Avery Brook Homes

Water Quality Concerns of Groton Utilities

Michael Giggey, PE August 22, 2024

Groundwater Contours Reported by Angus McDonald

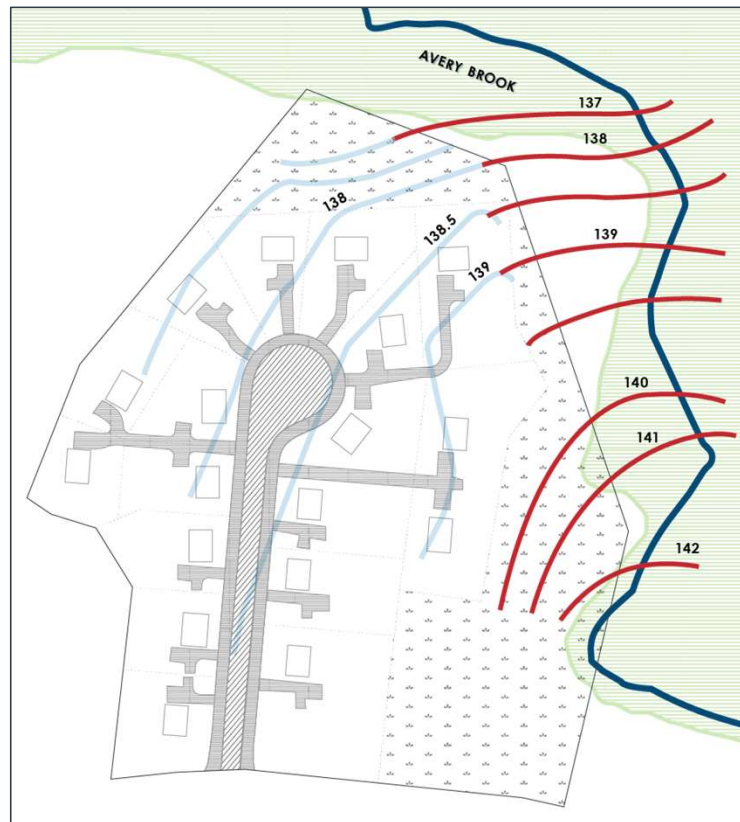
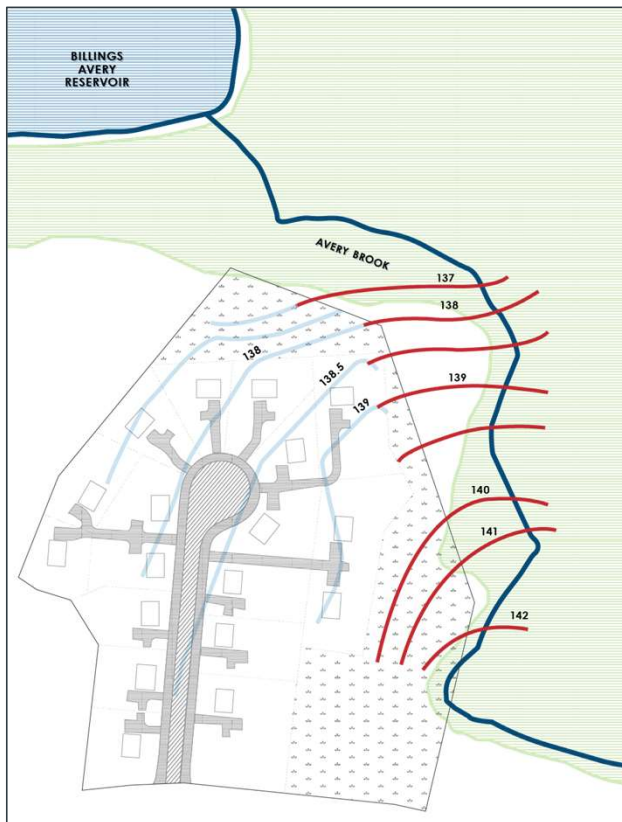
- Water table data limited to central portion of site
- Apparent northwesterly flow of groundwater

- Contours bend to the east as groundwater interfaces with Avery Brook
- Expect more groundwater flow to the north
- Much of recharge from 94 Stoddards Wharf Road flows to the north

Virus Inactivation—distances reported by Angus McDonald

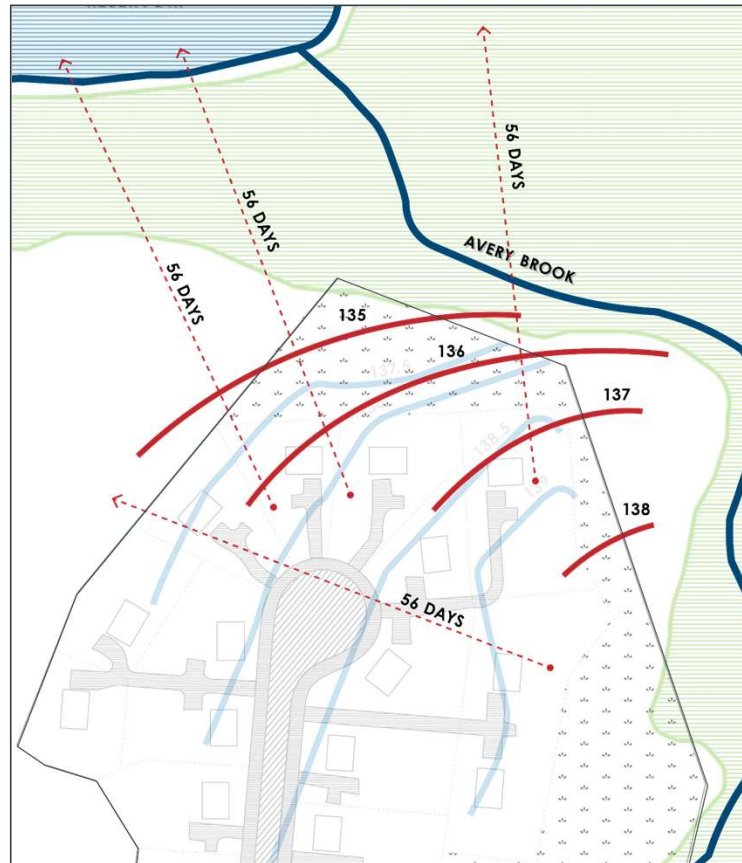
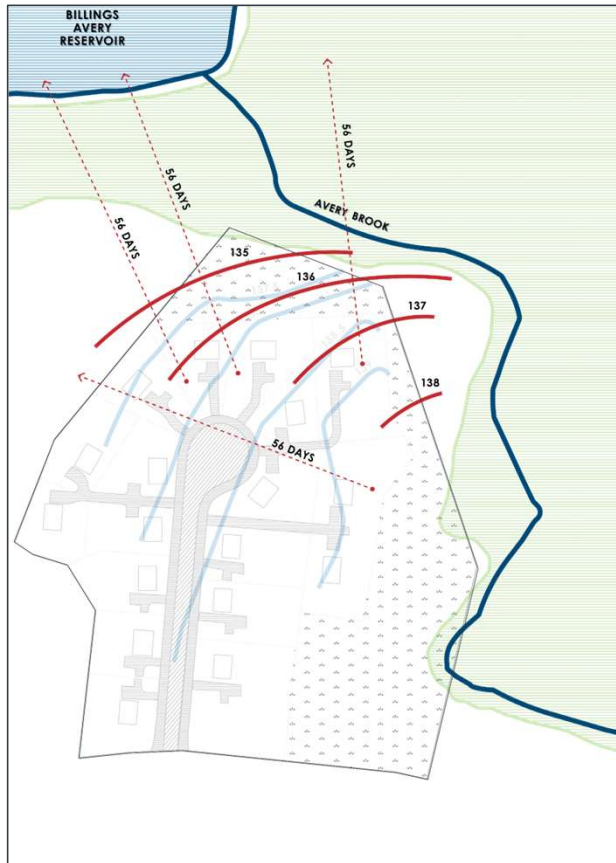
- Based on northwesterly flow
- Based on 21-day inactivation period
- Demonstrated impact on abutters

- Consider likely flow to the north
- Consider 56-day inactivation period
- Expect impacts on
 - Avery Brook
 - Billings Avery Reservoir
 - Many on-site potable wells
 - Abutters' wells

Groundwater Nitrate Map

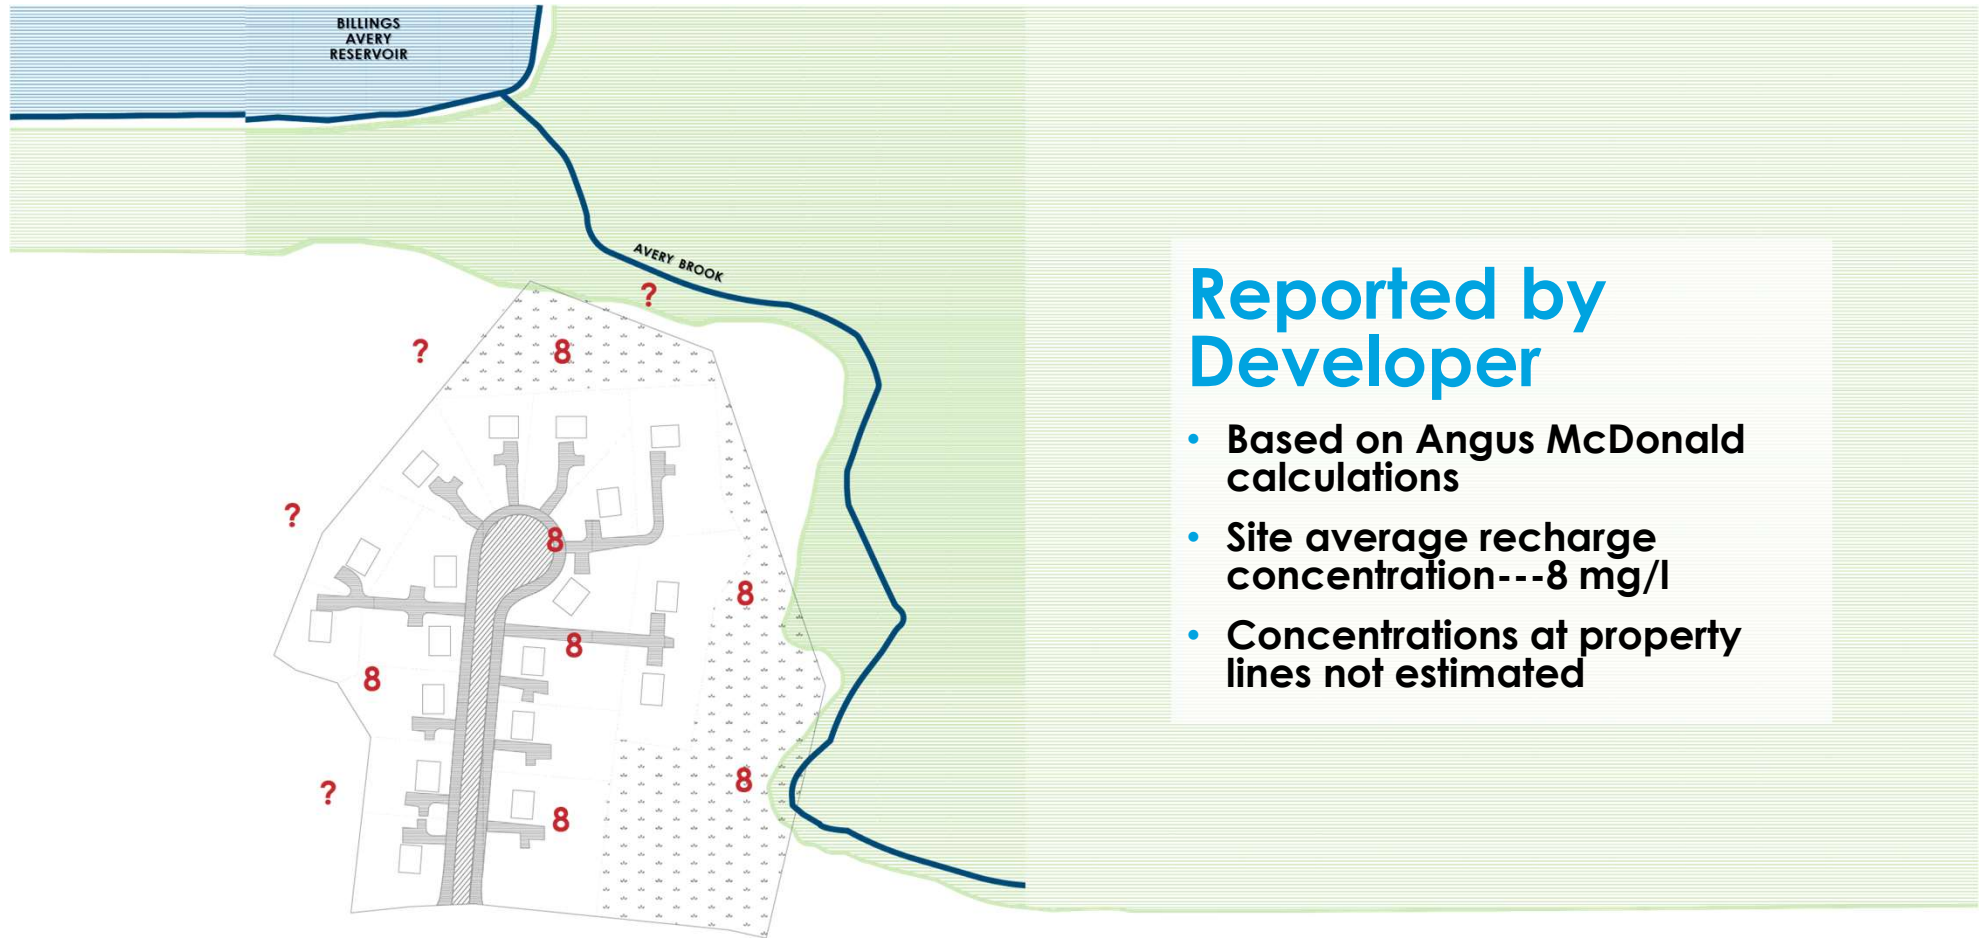
- Based on Angus McDonald calculations
- Site average recharge concentration---8 mg/l
- Concentrations at property lines not estimated

Groundwater Nitrate Map

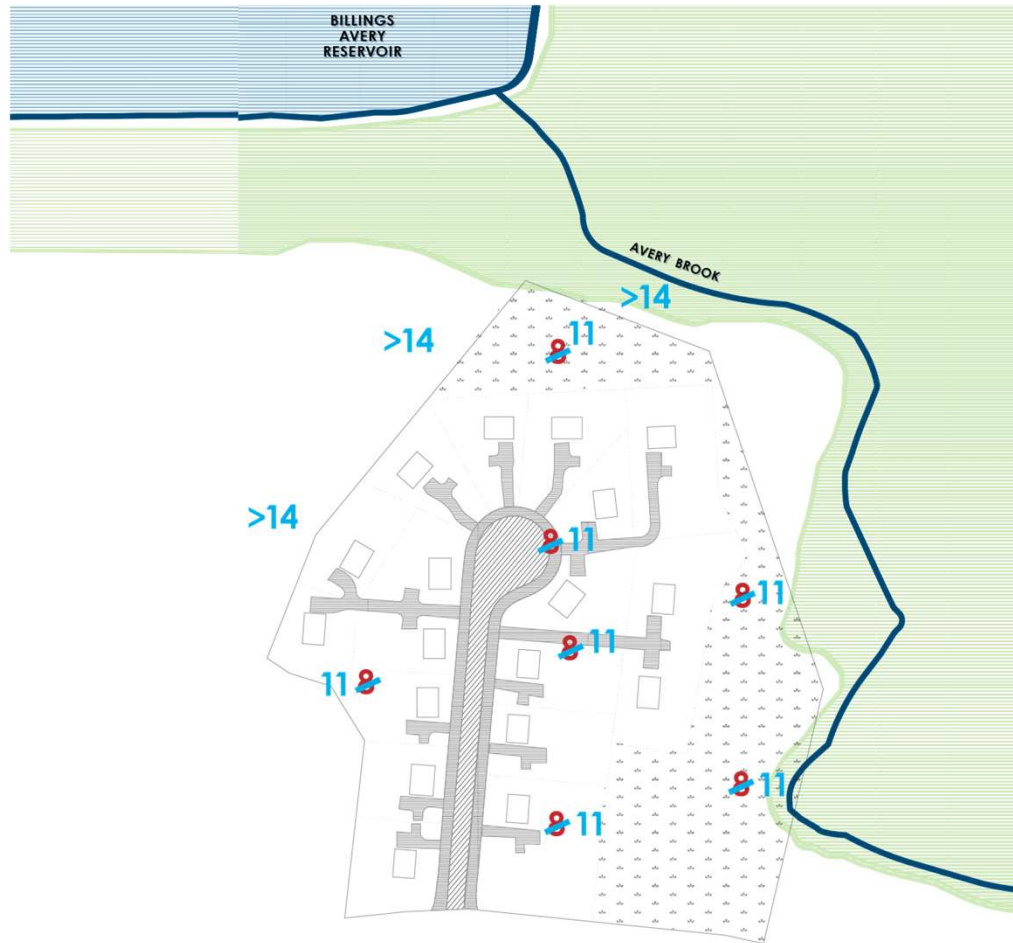
- Based on Wright-Pierce calculations
- Site average recharge concentration—11 mg/l
- Property line calculations well above 10 mg/l

Groundwater Nitrate Map

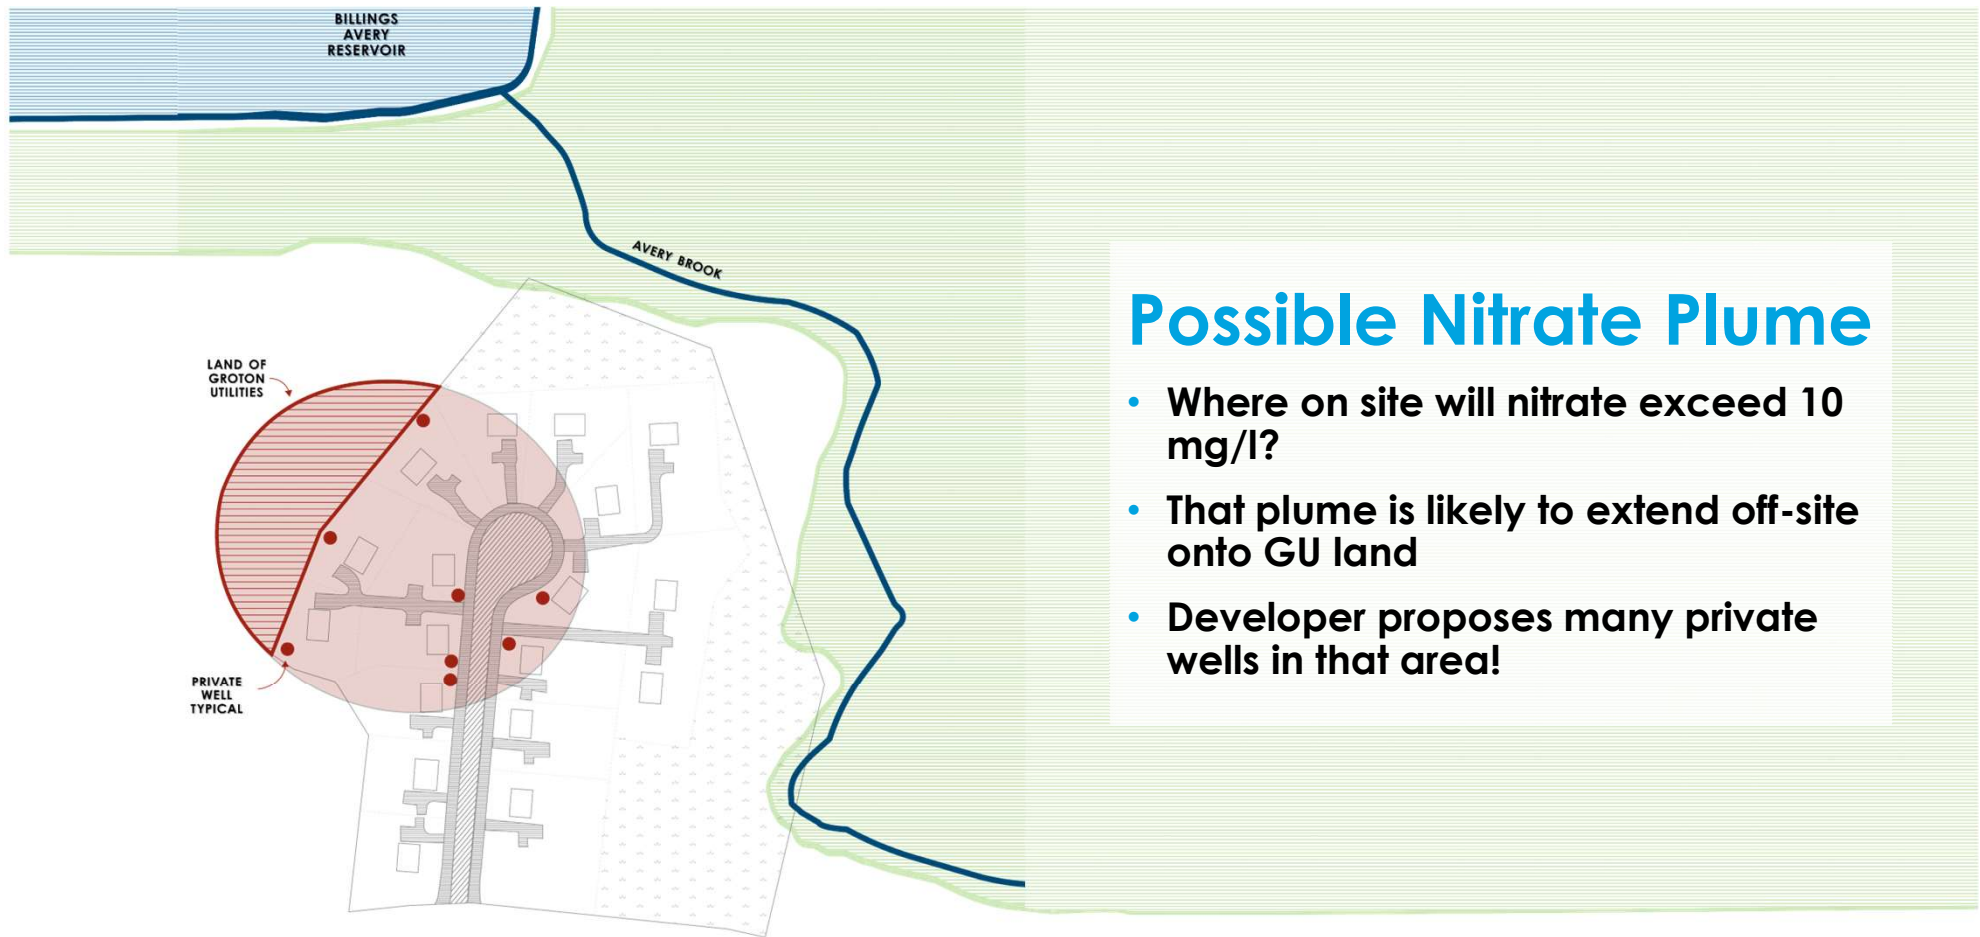
- Where on site will nitrate exceed 10 mg/l?
- That plume is likely to extend off-site onto GU land
- Developer proposes many private wells in that area!
